| TYPE | YEAR | PROJECT NO. | SHEET NO. |
|---|---|---|---|
| R.O.W. | 2015 | HSIP-106(33) | 31 |
| CONST. | 2017 | HSIP-106(33) | 41 |

CRITZ LANE WILLIAMSON CO.

BEGIN STA. 19+50.00
END STA. 20+00.00

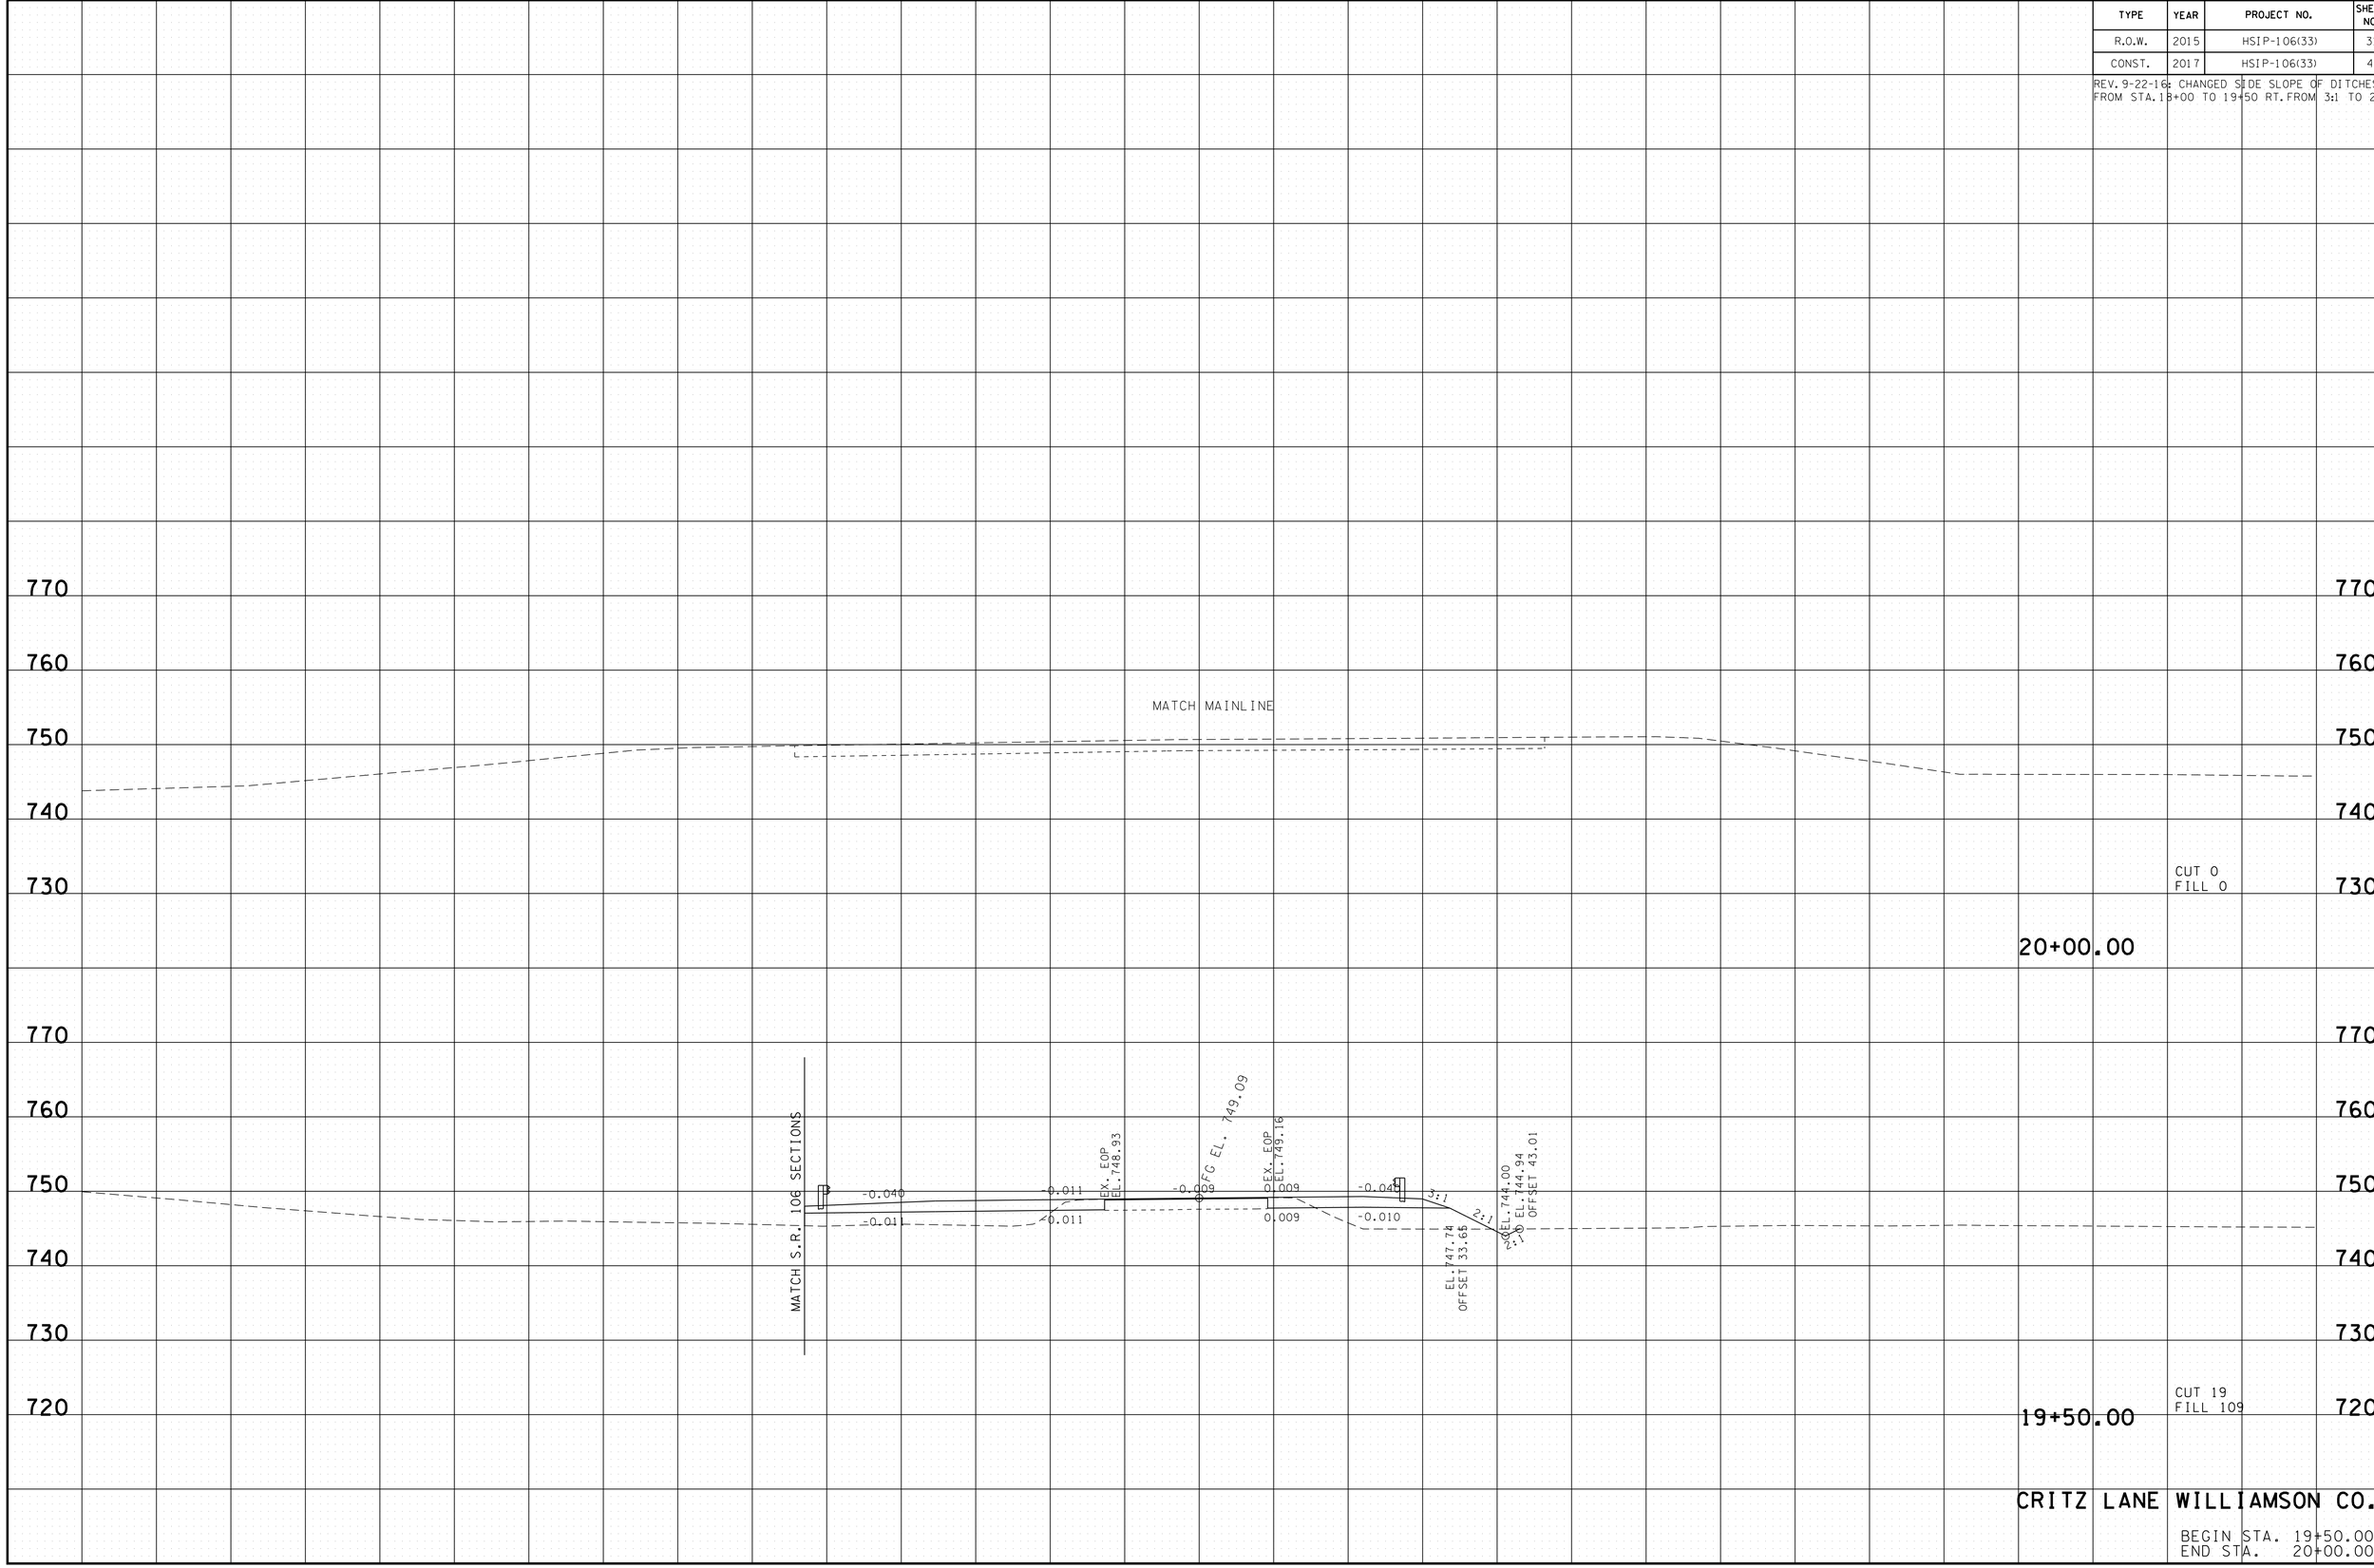
REV. 9-22-16: CHANGED SIDE SLOPE OF DITCHES FROM STA. 18+00 TO 19+50 RT. FROM 3:1 TO 2:1.
